CSGR FAN BOARD

REV	DESCRIPTION	ISSUE DATE
00XP0	PROTO BUILD

Ufi Space Co., Ltd.		CONFIDENTIAL
Title 01. TABLE OF CONTENTS		
Size	Document Number	Rev
	Project: Aphache	00XP0
Date:		Sheet 1 of 4

FROM MAIN BOARD CONNECTOR

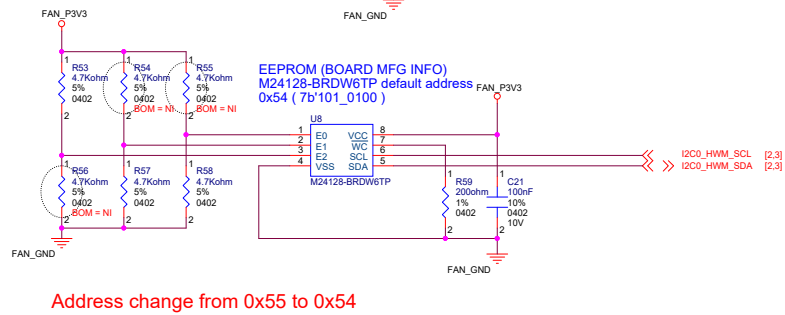
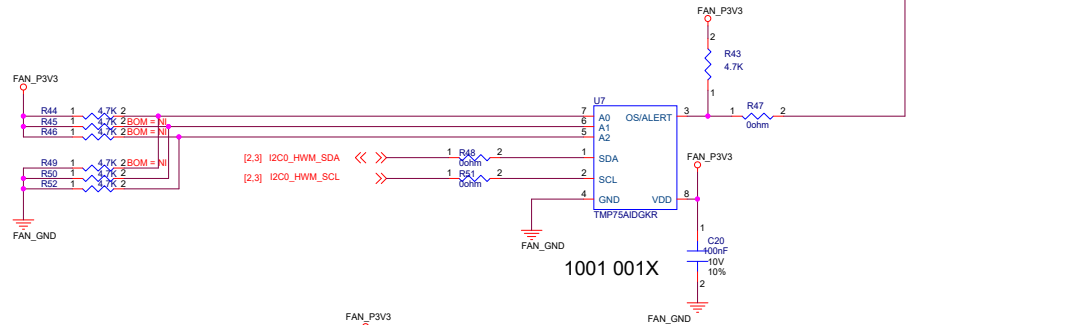
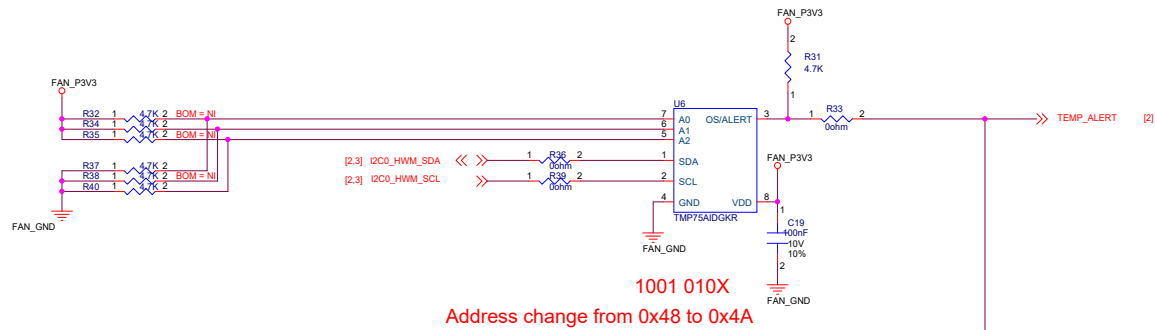
Add PD resistor for /CLR

Voltage Rating should be >+20V Change to 18V/25V
